BLDR - 2023-28886

PERMIT # OSWP-2023-37468

SEPTIC: IMPROVEMENT PERMIT / AUTHORIZATION TO CONSTRUCT / OPERATION PERMIT / EXISTING SYSTEM

916 Westminster Dr.
Statesville

AS BUILT SKETCH

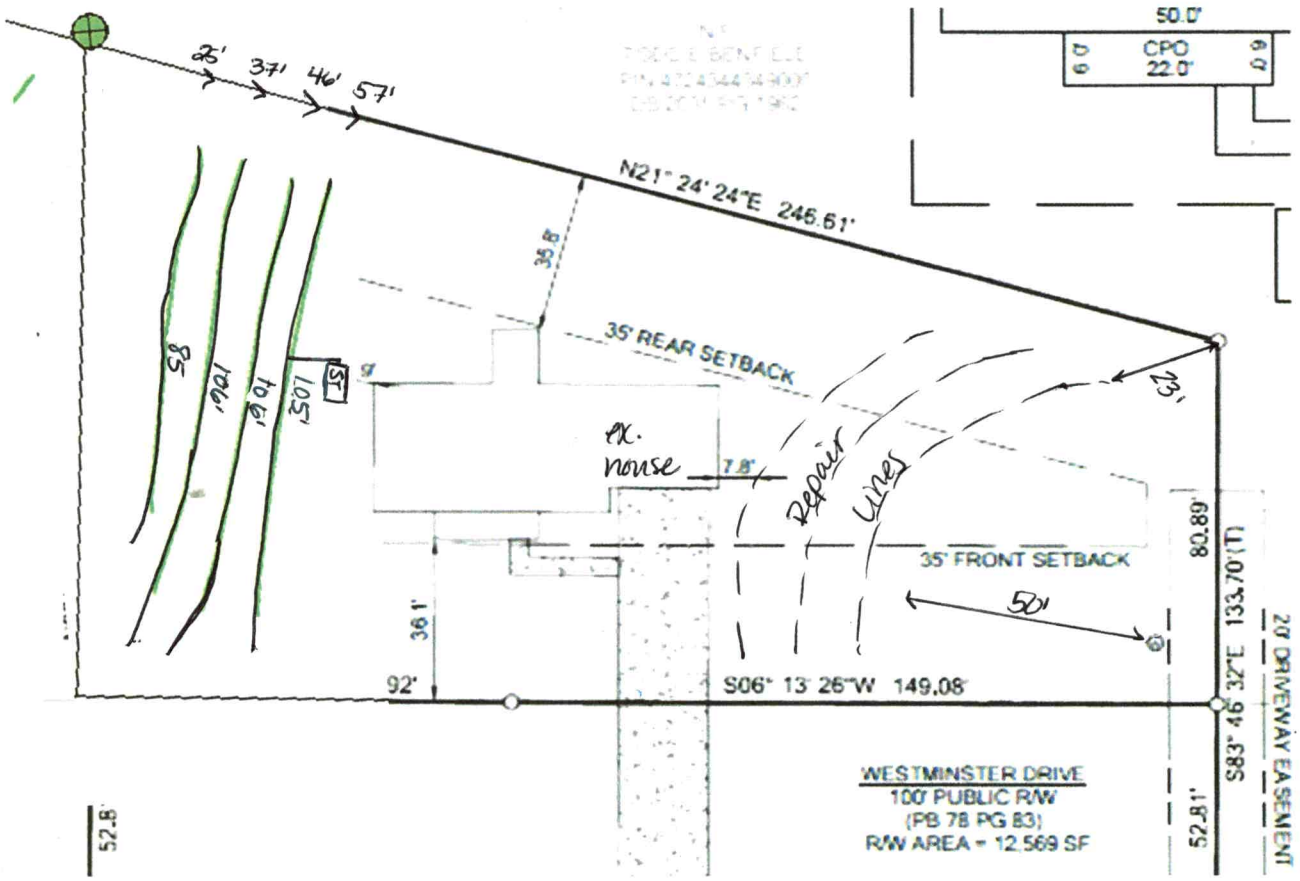
Comments / Conditions: Trench bottom varies across drainfield - see updated soil notes

Trench bottom
varies across lines
b/w 20-36"

Site plan reflects as built installation

AS BUILT SKETCH

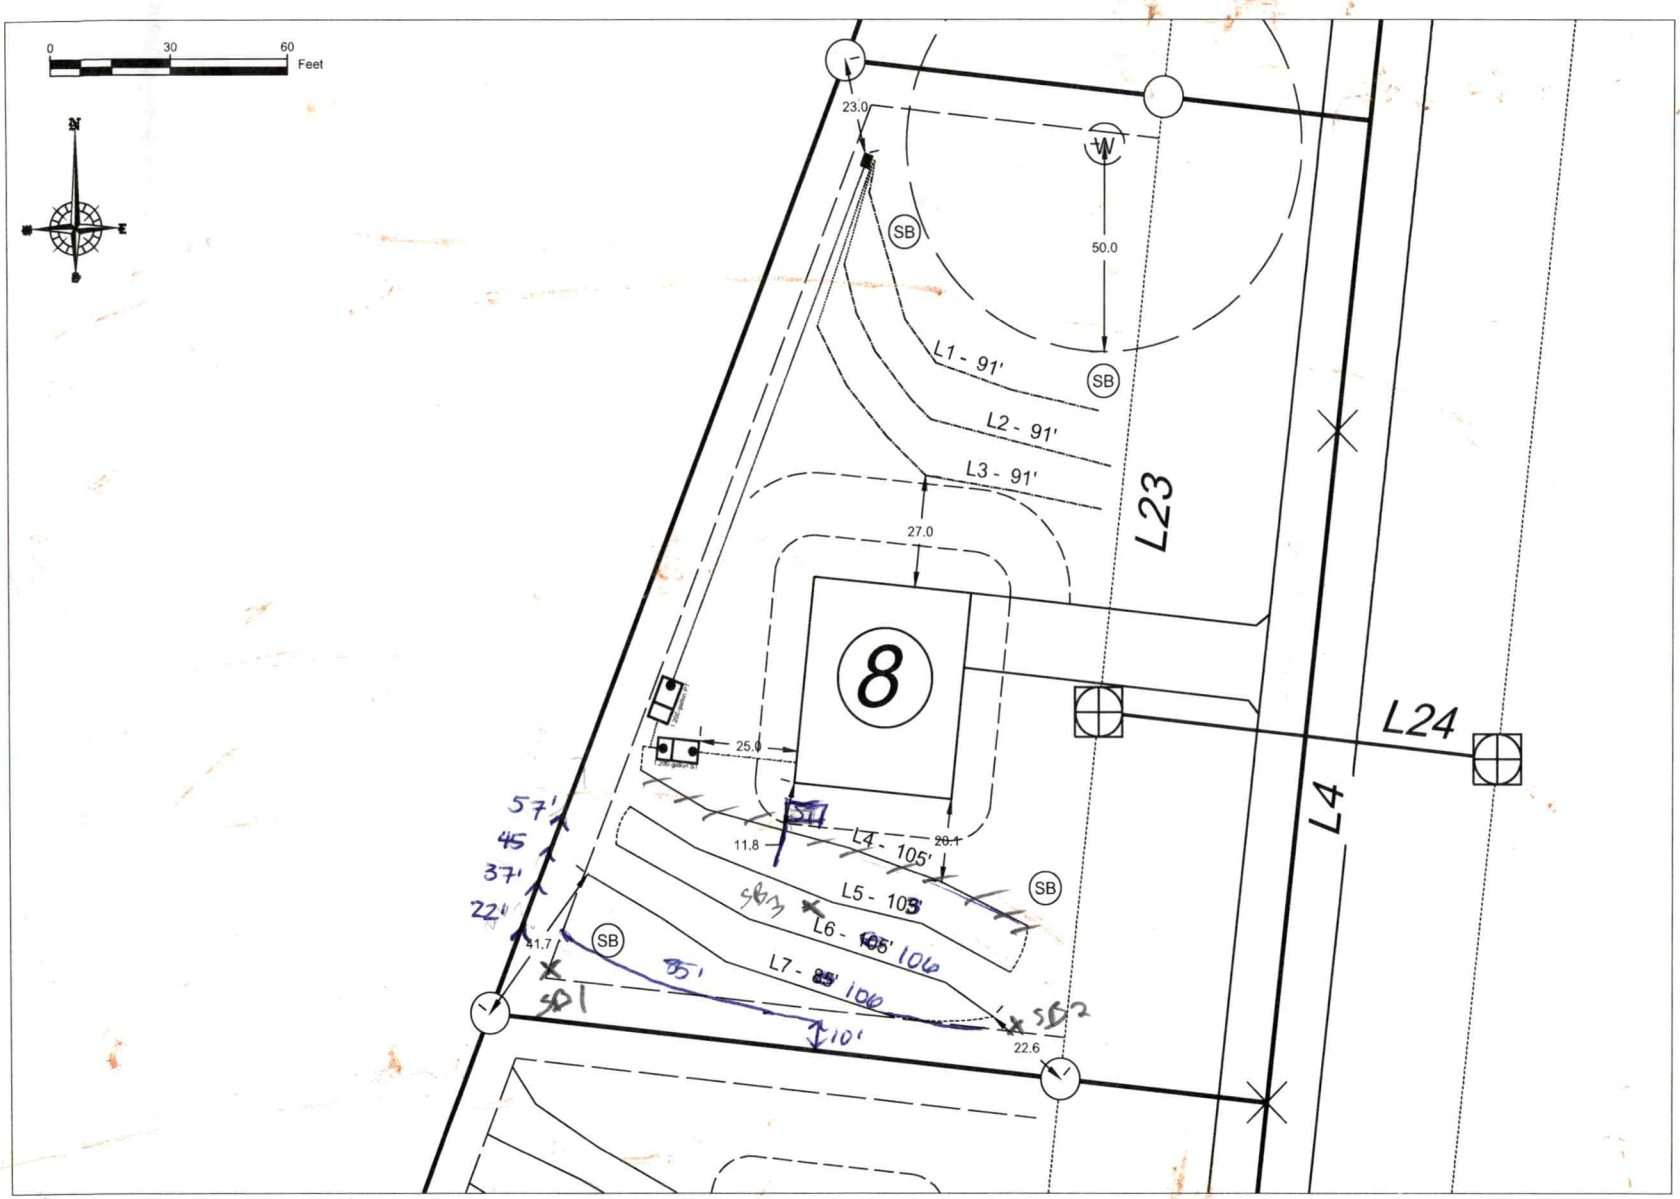
- Trench bottom exceeded all lines
- see as built for line locations - contour changed, lines moved down hill.
- will need soil scientist eval before signing off.

Hybrid/SAP system on primary

20-36" T.B throughout Lines
